# UNITED STATES PATENT AND TRADEMARK OFFICE

| APPLICATION NO.  | FILING DATE | FIRST NAMED INVENTOR | ATTORNEY DOCKET NO.           | CONFIRMATION NO.       |
|--|-------------|----------------------|-------------------------------|------------------------|
| 10/526,458   | 03/03/2005  | Reinhold Opper       | A-10274                       | 3831                   |

## Office Action Summary

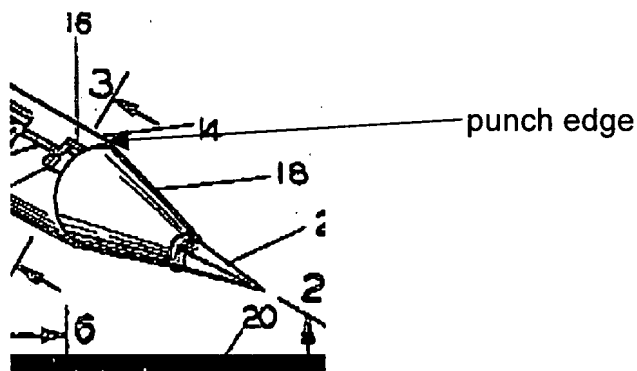
Claims 1-3, 5, 8, 10, 11, 14-16 18, 20, 22, 23, 26 and 27 are rejected under 35 U.S.C. 102(b) as being anticipated by Tendler (US 3,398,627). Tendler discloses a blind rivet (A) comprising a hollow shank (9-11) having a sethead (4), a deformation segment (see Fig. 8) and a connection segment for connecting to a foot (19) of a

mandrel (21). The shank includes an end face (20, 28) having an outer periphery which meets the outermost periphery of the shank to form a punch edge (see below) and the mandrel forms a protrusion (28) at the center of the end face though an open end of the shank. The end face is shown to be overall smooth with a conical (at 20) and pyramidal (at 28) surface and is circular in cross section (see Fig. 3). The mandrel includes a widened head and the other end is inherently hardened by the formation of the threads and pointed tip.
